SOUTH DUBLIN COUNTY COUNCIL

INTERNAL MEMORANDUM

Development: The construction of 569 dwellings, a creche, innovation hub and open space in the Clonburris South West Development Area of the Clonburris SDZ Planning Scheme 2019 as follows: 173 houses comprising 8 two bedroom houses, 153 three bedroom houses and 12 four bedroom houses (147 dwellings in CSW-S4 consisting of 8 two bedroom houses, 127 three bedroom houses & 12 four bedroom houses & 26 three bedroom dwellings in CSW-S3), all 2 storey comprising semi-detached, terraced, end terrace units (with parking and private open space); (B) 148 duplex apartments/apartments (88 in CSW-S4 & 60 in CSW-S3) comprising 74 two bedroom units and 74 three bedroom units, in 16 three storey buildings. In CSW-S4 Duplex Blocks A,B,C,D,E,F,G,J,K, comprise 8 units (4 two bed & 4 three bed units), Duplex Block H comprises 16 units (8 two bed & 8 three bed units), In CSW-S3 Blocks L, N & O comprise 8 units (4 two bed & 4 three bed units), Block M comprises 14 units (7 two bed & 7 three bed units), Block P comprises 10 units (5 two bed & 5 three bed units), Block Q comprises 12 units (6 two bed & 6 three bed units), all to have terraces/pitched roof;

Figure 2.3.1 | Green Infrastructure

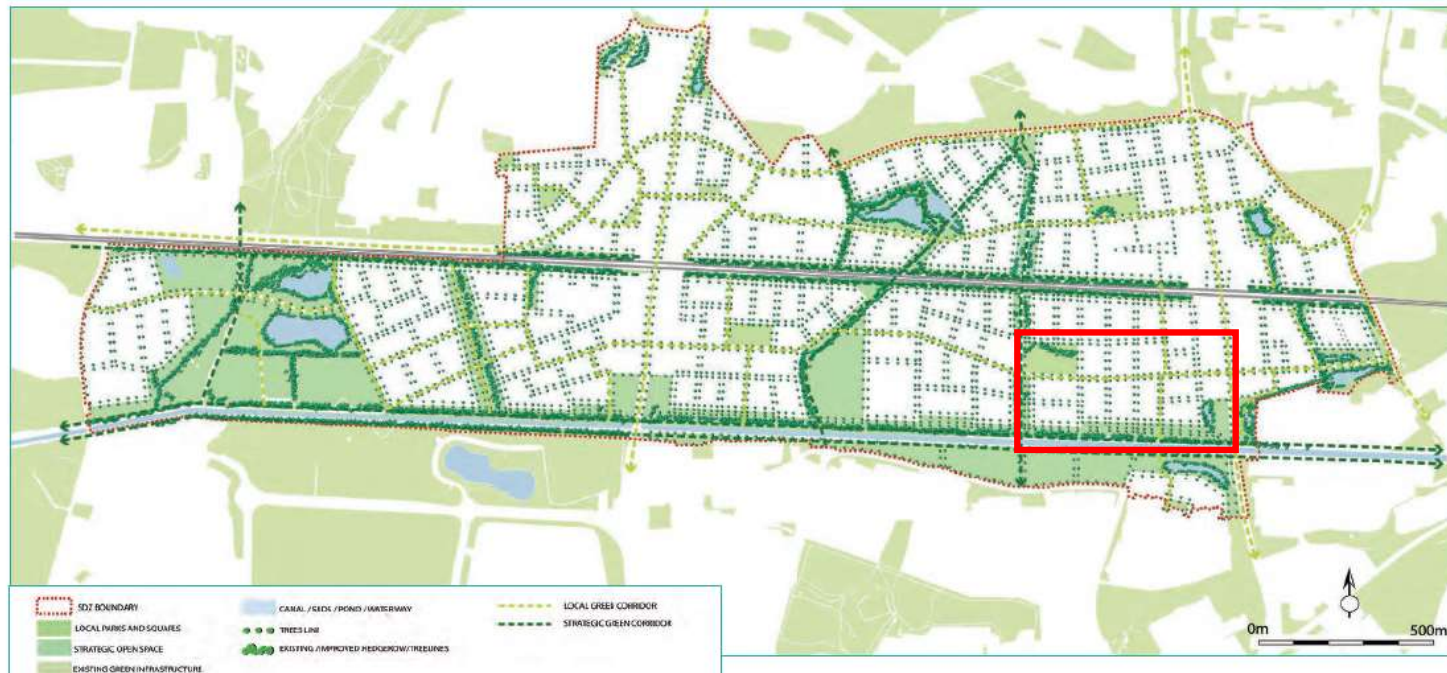
The Green Infrastructure Network required by Clonburris SDZ Planning Scheme is shown in Figure 2.3.1 of the Scheme (see above).

The Planning Scheme designates:

- A **Strategic Green Corridor** linking the Grand Canal and Railway Strategic Green Corridor along the **western-most boundary** of the proposed development area, along Street 7.
- **Local Green Corridors** along Clonburriss Link Street; Fonthill Road and Street 2.
- **Tree Lined Streets** throughout with street trees on *both sides*.

- i. A Strategic Green Corridor along the Western Boundary by extending the planting proposed within the western boundary of the Local Park southwards and including nature based SuDS.

- ii. A Local Green Corridor within Street 2 incorporating nature based SuDS: planting proposals require strengthening as there is no difference between it and the tree planting proposed on the other local streets and homezones.

- iii. Provision of street trees on both sides along local streets and homezones.
- iv. Provide a Green Infrastructure Plan: demonstrate compliance with the requirements of 12.4.2 of the County Development Plan: ,i.e. how they contribute to the protection or enhancement of Green Infrastructure in the County through the provision of green infrastructure elements, having regard to:
